SUBJECT: ISSUANCE OF AMENDMENT NO. 36 TO FACILITY OPERATING LICENSE
NO. R-2 — PENNSYLVANIA STATE UNIVERSITY (PENN STATE) BREAZEALE
REACTOR (TAC NO. MC2493)

AMENDMENT TO FACILITY OPERATING LICENSE

Amendment No. 36
Licensee No. R-2

SAFETY EVALUATION BY THE OFFICE OF NUCLEAR REACTOR REGULATION

ENCLOSURE TO LICENSE AMENDMENT NO. 36

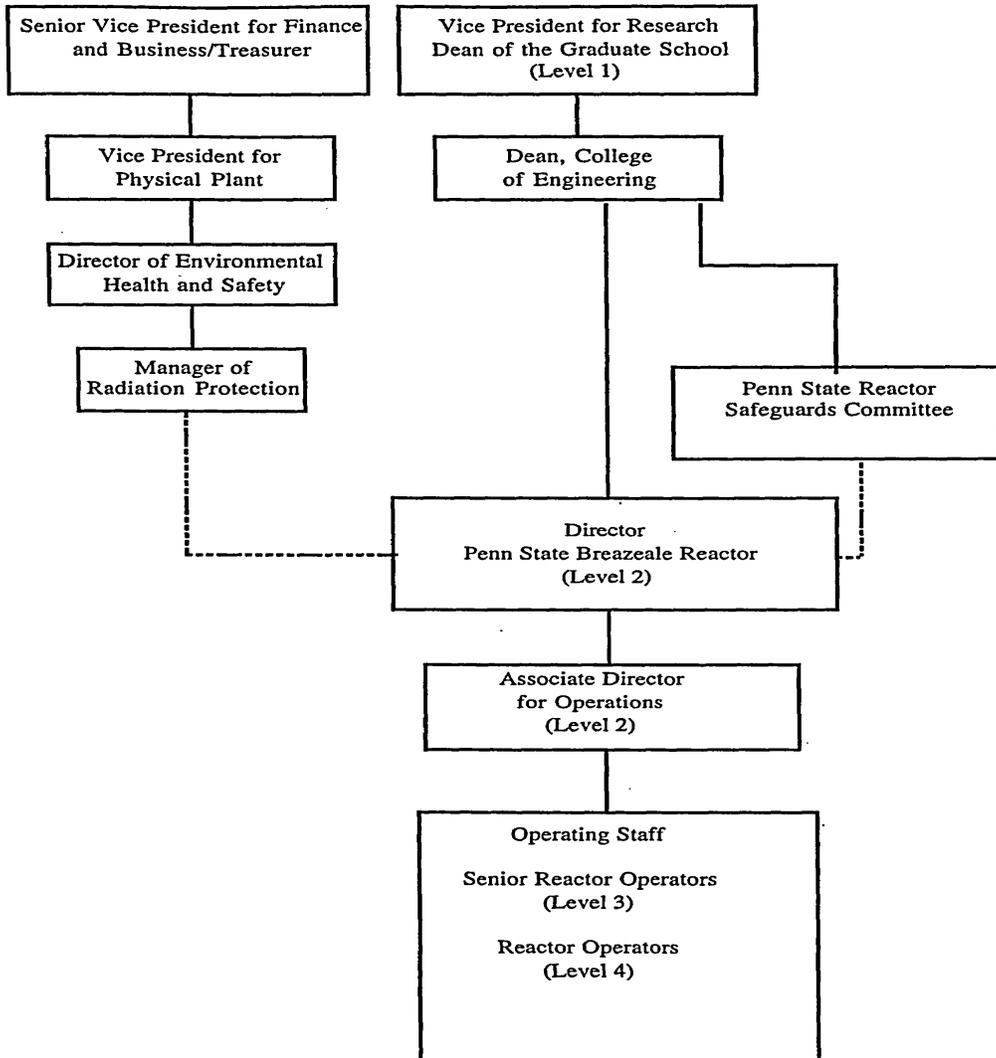
Replace the following page of the Appendix A Technical Specifications with the enclosed page. The revised page is identified by amendment number and contain vertical lines indicating the areas of changes.

The PSBR is a 1 MW(t) research reactor located on the licensee's campus in University Park, Pennsylvania. The requested amendment to the Technical Specification 6.1.1 organizational chart for the facility is to replace the position of Manager of Operations and Training with the position of Associate Director for Operations. Code of Federal Regulations (CFR) Title 10, Part 50, Section 36, "Technical specifications," subsection (5), requires "Administrative controls," "relating to organization and management ... necessary to assure operation of the facility in a safe manner."

The proposed change is to the administrative controls section of the Technical Specifications. It changes the position title of Manager of Operations and Training to Associate Director for Operations. The licensee indicated that this change strengthen the responsibilities and authorities of that position. The licensee further stated that the Associate Director for Operations will be function as a Level 2 as defined in American National Standards Institute/American Nuclear Society Standard 15.4, 1988, "American National Standard for the Selection and Training of Personnel for Research Reactors." The Manager of Operations and Training was at a Level 3 in the Technical Specifications. Further, the licensee stated that Senior Reactor Operators function as a Level 3 in accordance with ANSI/ANS 15.4-1988. The previous organizational chart had Senior Reactor Operators function at a Level 4 position.

The staff determined that the proposed organization structure, functional levels qualifications and assignment of responsibilities is consistent with the provisions of ANSI/ANS 15.4-1988 and ANSI/ANS 15.1-1990, "The Development of Technical Specifications for Research Reactors." NRC's NUREG-1537, "Guidelines for Preparing and Reviewing Applications for the Licensing of Non-Power Reactors, Standard Review Plan and Acceptance Criteria" February 1996, states that ANSI/ANS 15.1 and 15.4 are acceptable for structure, functional levels qualifications and assignment of responsibilities.

Based on the above, these changes are acceptable.
